Panel Report

**Bayside Planning Scheme Amendment C160bays
Highett Structure Plan 2019**

20 April 2020

Figure 4 Clause 21.02-5 Map 2 – Residential Strategic Framework Plan excerpt

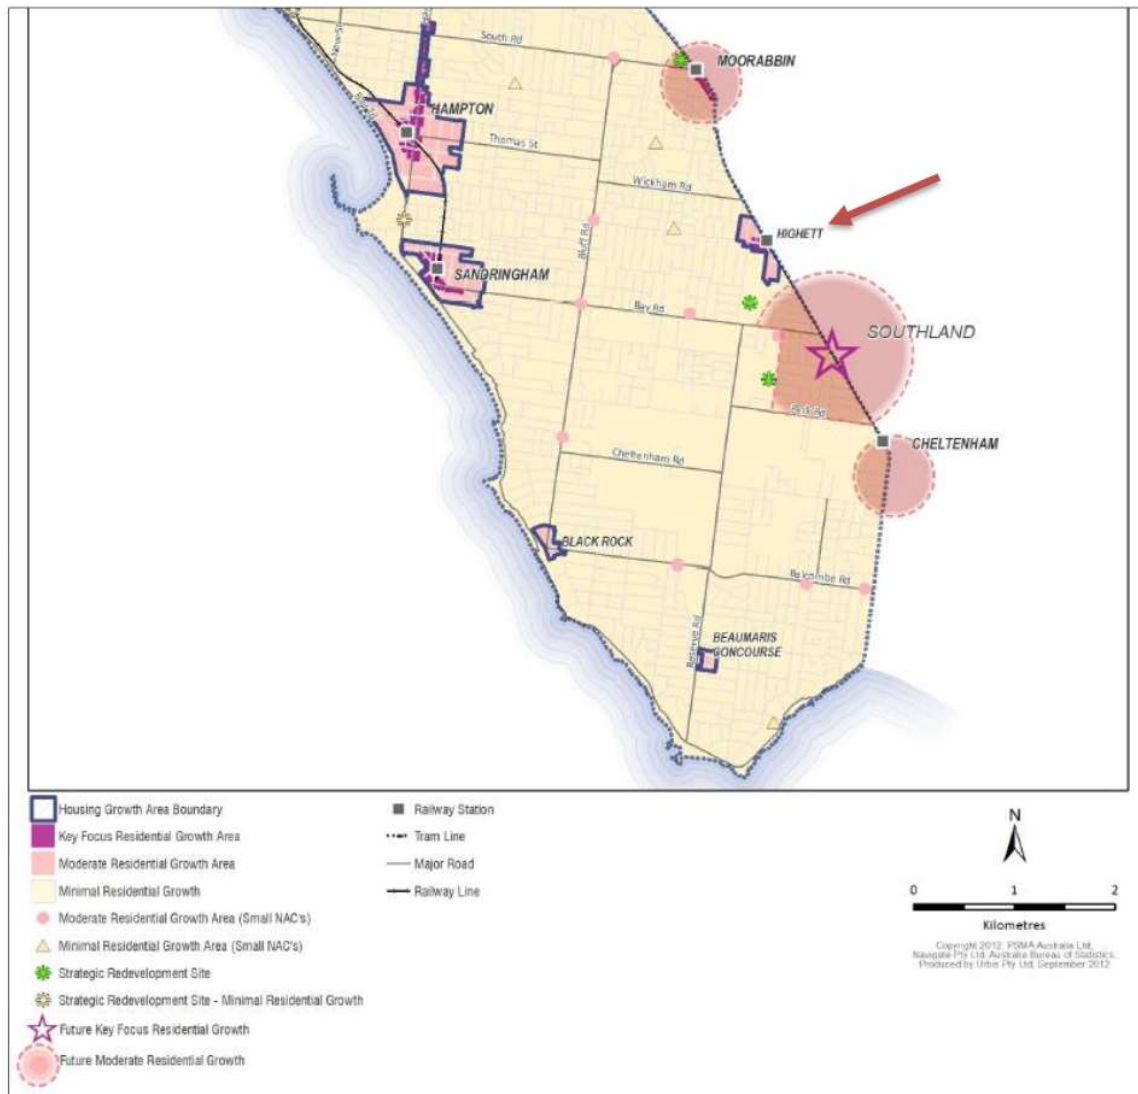
3. Amend 'Map 2 – Residential Strategic Framework Plan' in Clause 21.02 to align the boundaries of the Highett Activity Centre with the Highett Structure Plan, September 2018.

- corrections to the exhibited Planning Scheme zone maps
- amend Clause 21.02 inserting a new 'Map 2 – Residential Strategic Framework Plan' reflecting the revised Structure Plan boundary

Figure 11 Council’s post exhibition changes to Map 1: Highett Activity Centre Built Form Provisions

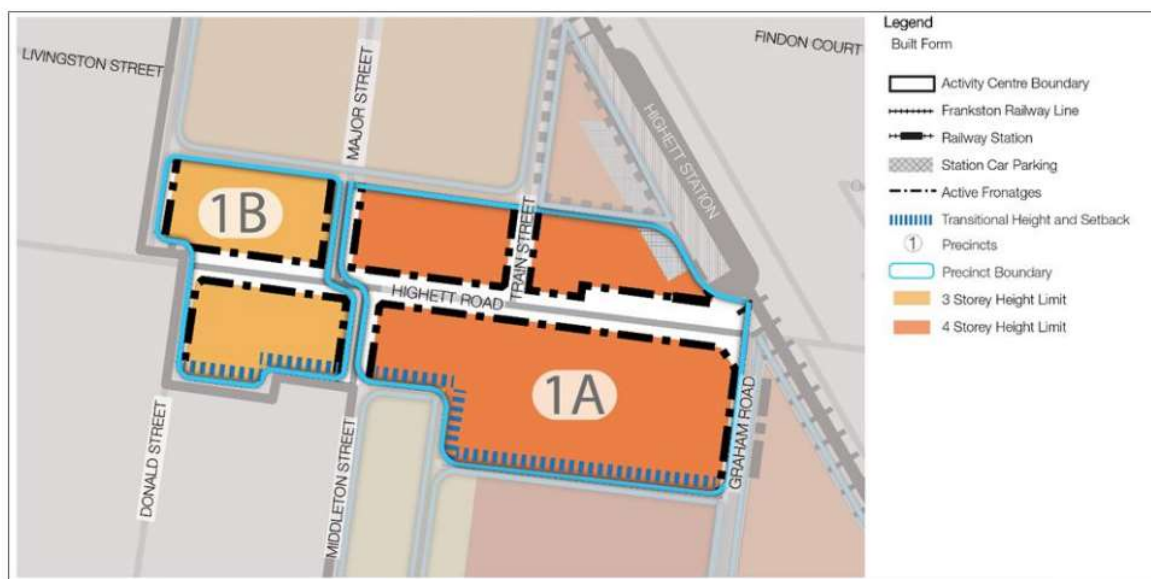
As identified in Chapter 4, Council’s post exhibition changes to DDO4 included the simplification of design objectives and amending ‘Map 1: Highett Activity Centre Built Form Provisions’ to extend the ‘Transitional Height and Setback’ linework along the boundaries with precincts to the south and remove legend references to 5 and 2 storey maximums and open space/pedestrian linkages which are not relevant (as shown in Figure 11).

The Panel generally supports the changes to Map 1. While it supports the continuation the Transitional Height and Setback linework to Precinct 5 and adjoining GRZ1 areas it does not support the continuation of this provision adjacent to the CSIRO site. The built form of Precinct 1A adjacent to the CSIRO site is largely established and the CSIRO site is likely to have taller development elements towards this end of the site removing the need for this transition provision. The Panel notes that the urban design advice informing the Structure Plan does not propose this transition element to the CSIRO site (it does for the other areas proposed by Council). Council's revised Map 1 to Clause 21.11-6 does not show this extent either.
